**METROPOLITAN GOVERNMENT OF NASHVILLE AND DAVIDSON COUNTY**

**STAFF RECOMMENDATION**  
**910-916 Granada Avenue**  
**August 19, 2015**

**Application:** New construction-infill  
**District:** Greenwood Neighborhood Conservation Zoning Overlay  
**Council District:** 06  
**Map and Parcel Number:** 08204041500, 08204041600, 08204041700, 08204041800  
**Applicant:** Josh Randolph, Aerial Development  
**Project Lead:** Paul Hoffman, paul.hoffman@nashville.gov

**Figure 6. Contributing building to the right of building site.**

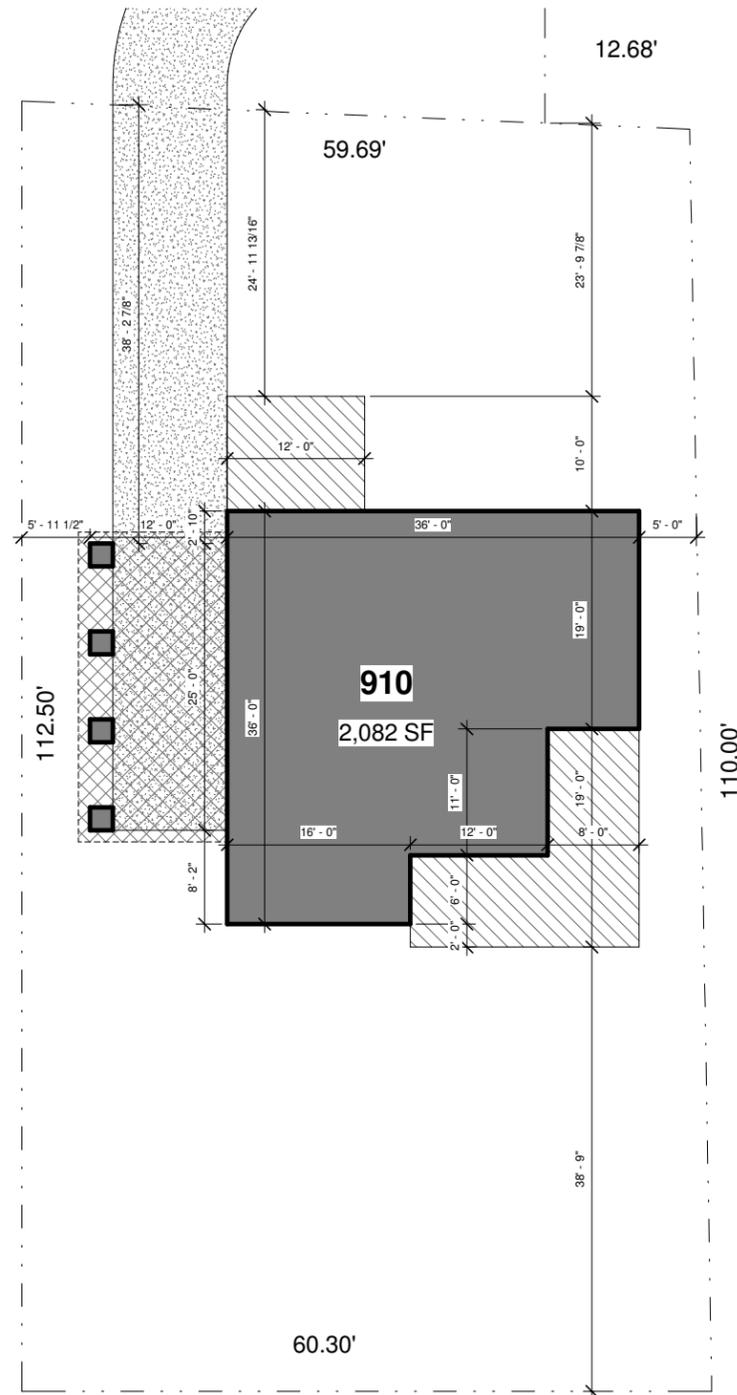
**Height & Scale:** The four proposed two-story buildings on Granada Avenue range from thirty feet, eleven inches (30'11") to thirty-three feet, four inches (33'4") in height and approximately thirty-two feet (32') wide. The only contributing context is the bungalow at 906 Granada Avenue, which is twenty-three feet (23') tall and thirty-two feet wide (32'). The widths of these four buildings range between thirty-two to thirty-six feet (32'-36'). The proposed structures are taller and wider than the historic building in the immediate vicinity. Given the lack of immediate historic context, Staff assessed the heights and widths of historic buildings nearby. There are several two-story contributing homes along Seymour and Chicamauga Avenues that range in height between twenty-five feet and thirty-five feet (25'-35'). The Commission also approved an addition in 2013 to a non-contributing building across Manila Avenue from the current project that increased its height to twenty-seven feet (27'). The widths of the few contributing buildings nearby are from thirty-two to forty-five feet (32'-45'). The proposed buildings meet this broader historic context in terms of massing. Staff finds the two-story designs and the overall widths and heights to be appropriate. The project meets sections II.B.1.a and b.

## 916 GRANADA AVE SITE PLAN

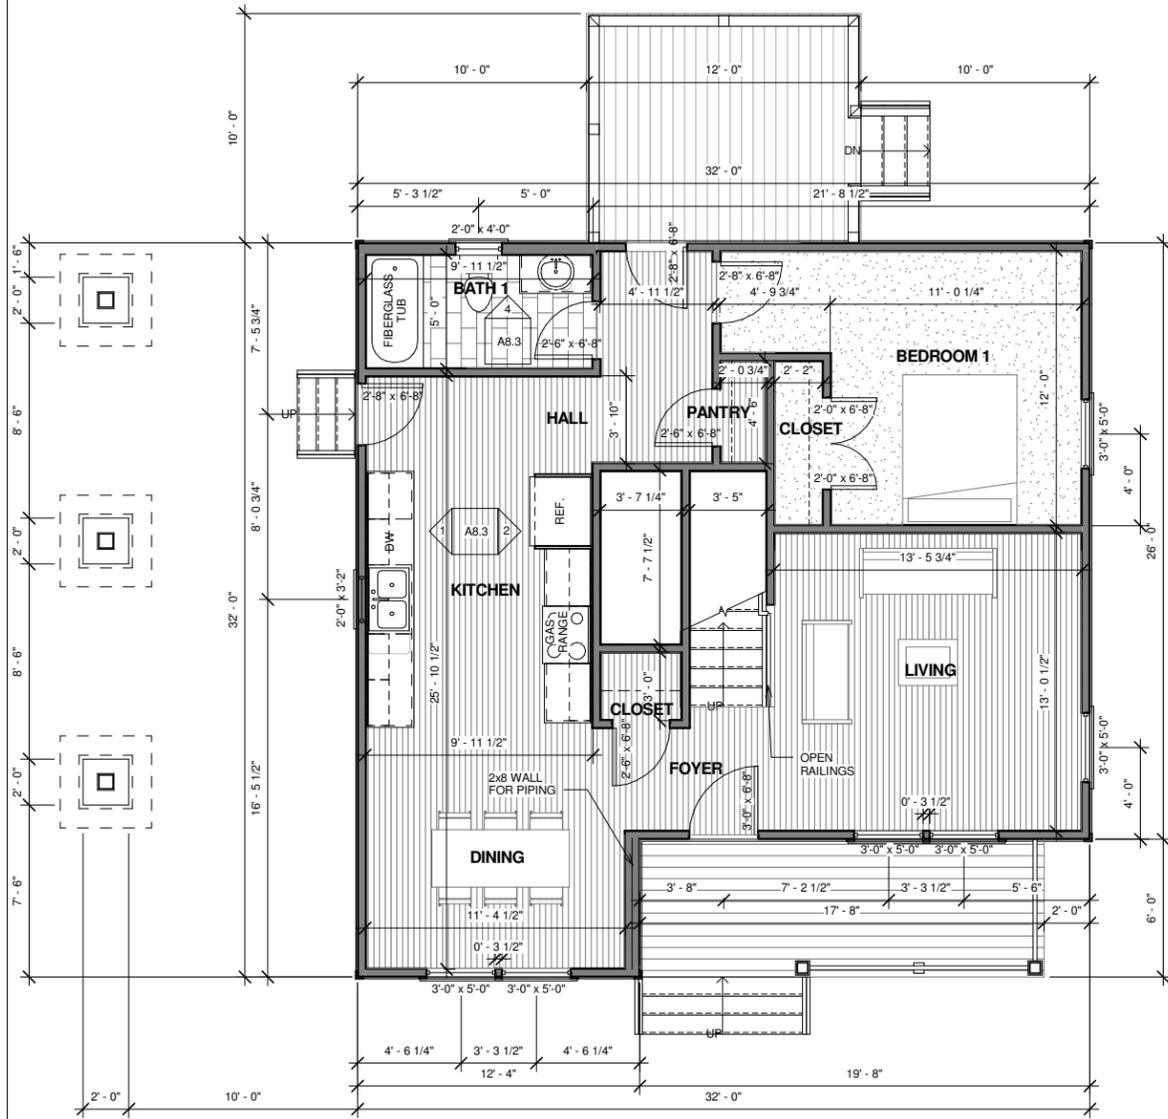
**Materials:** The materials for the five proposed structures are similar. The cladding will be fiber cement siding with a five inch (5") reveal. Foundations will be split-faced concrete block. Roofing will be architectural shingles; the porch roofs on 914 and 916 Granada Avenue are metal. Staff recommends having final review of roofing color. Trim will be fiber cement boards. The gable fields will be fiber cement board-and-batten. Porch columns, decking and railing will be wood. The doors will be fiberglass doors with half-light to three-quarter light glass. The drawings indicate PlyGem vinyl windows are intended for all of the buildings; these windows have not been approved for new construction. Staff therefore requests final approval of window and door selections. Walkways and driveways will be concrete. With the staff's final approval of the windows and doors, and color of roofing material, the known materials meet section II.B.1.d.

1. The finished floor height shall be consistent with the finished floor heights of the adjacent historic houses, to be verified by MHZC staff in the field;
2. Staff approve the roofing color, and final details, dimensions and materials of windows and doors prior to purchase and installation; and,
3. The HVAC shall be located behind the house or on either side, beyond the mid-point of the house; and Staff approve the roof color and masonry color, dimensions and texture.
